Your Ref
WA/78/18/HH
Our Ref
PLAN-024510
Date
27/09/2018

Proposal: Single storey rear extension.
Site: Elm Cottage, Dairy Lane, Walberton, BN18 0PT.
WA/78/18/HH

Due to surface water inundation issues in the Lidsey Catchment "The applicant is advised to adopt, where appropriate, the measures in the table "Practical measures to reduce the potential impacts of development".

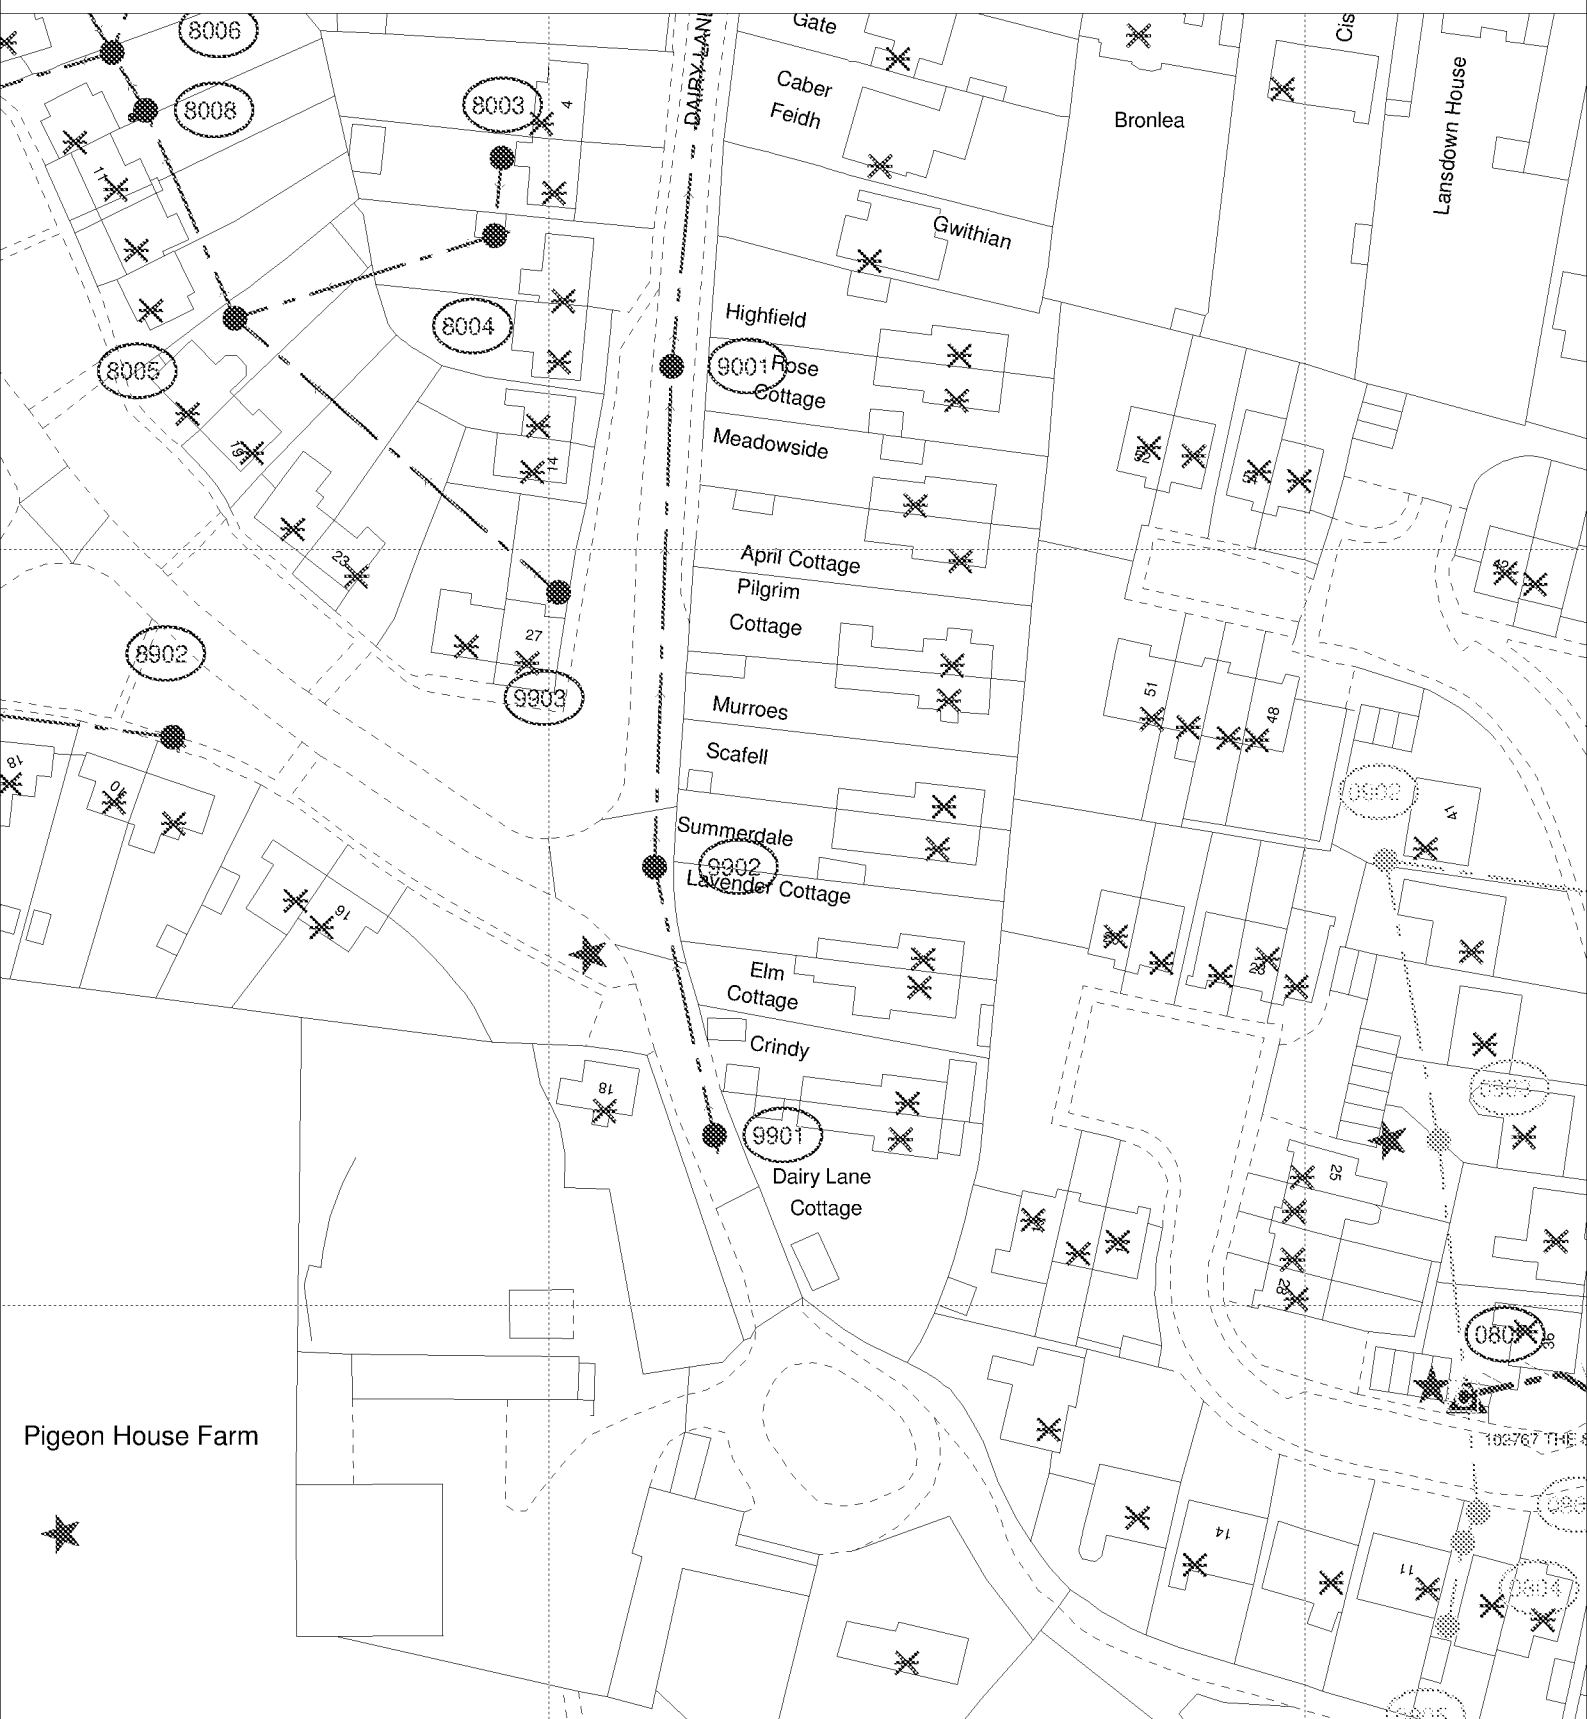
Developer should look to protect the public sewerage system from inundation and infiltration, which contribute to flooding in unfavourable conditions.
